Submit 1 Copy To Appropriate District	State of N	ew Mex	cico		Form C-103
Office	Energy, Minerals and Natural Resources			WELL ADINO	Revised July 18, 2013
1625 N. French Dr., Hobbs, NM 88240				WELL API NO. 30-015-44416	
<u>District II</u> - (575) 748-1283 811 S. First St., Artesia, NM 88210	OIL CONSERVATION DIVISION			5. Indicate Type of Lease	
<u>District III</u> – (505) 334-6178 1000 Rio Brazos Rd., Aztec, NM 87410	1220 South St. Francis Dr.			STATE FEE	
District IV - (505) 476-3460	Santa Fe, NM 87505			6. State Oil & Gas Lease No.	
1220 S. St. Francis Dr., Santa Fe, NM 87505					
SUNDRY NOTICES AND REPORTS ON WELLS 7. Le					nit Agreement Name
(DO NOT USE THIS FORM FOR PROPOSALS TO DRILL OR TO DEEPEN OR PLUG BACK TO A DIFFERENT RESERVOIR. USE "APPLICATION FOR PERMIT" (FORM C-101) FOR SUCH				STRIKER 2 SWD	
PROPOSALS.) 1. Type of Well: Oil Well Gas Well Other SWE OIL CONSERVATION ⁸ . Well Number 1

- The proposed wellbore design has changed as follows:					
o Plans to run 5" tubing inside the 7-5/8" liner (instead of 4-1/2" tubing) - Please see attached wellbore diagram reflecting changes

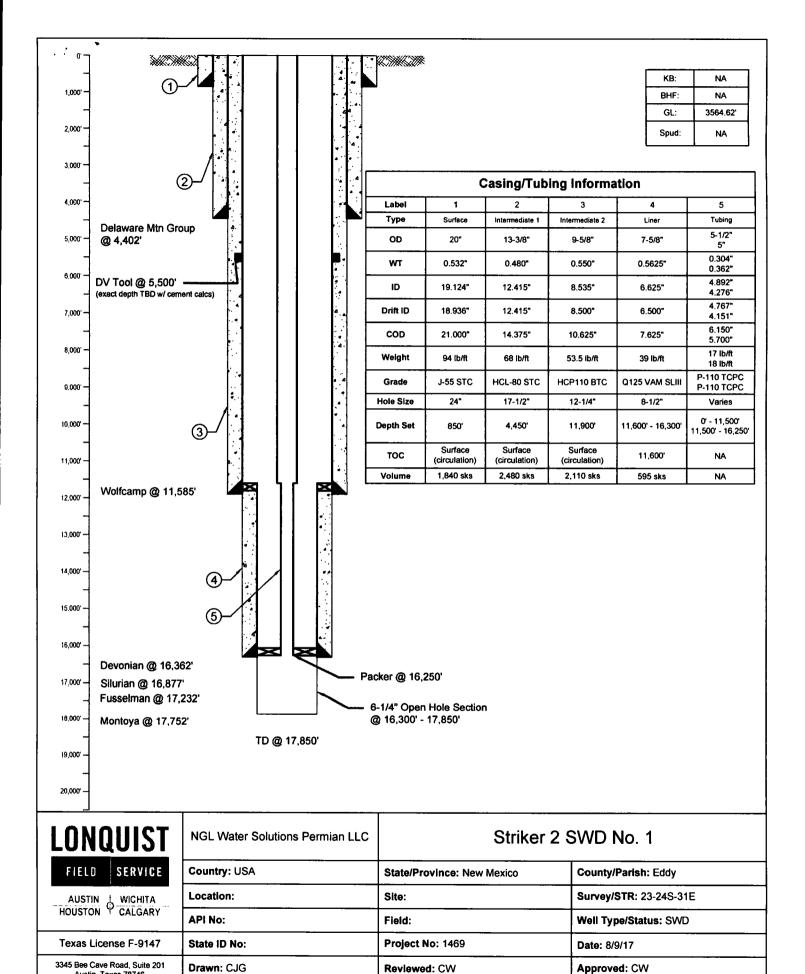
- Please see anached wemoore diagram reflecting changes					
	 -				7
Spud Date:	Rig R	Release D	ate:		
			<u> </u>		
I hereby certify that the information	n above is true and complet	te to the b	est of my knowled	dge and belief.	
// /	\ \ \				
SIGNATURE / /	J _t VI TITI	LE C	onsulting Enginee	r DATI	06/28/2018
Type or print nameChris Weya	nd E-m	ail addre	ss: <u>chris@lonqu</u>	ist.com PH	ONE: <u>(512) 600-1764</u>
For State Use Only					
APPROVED BY: Saymond In Edwy TITLE Golog 13t DATE 6-29-18					
Conditions of Approval (if any):					
Concurred by St W/PKG.					
Flore to AMEAD SUID- 1721					
PIANS TO AMENU SWA					
Concurred by SF W/PRG. Plans to AMEND SWD-1721 To Reflect size increase.
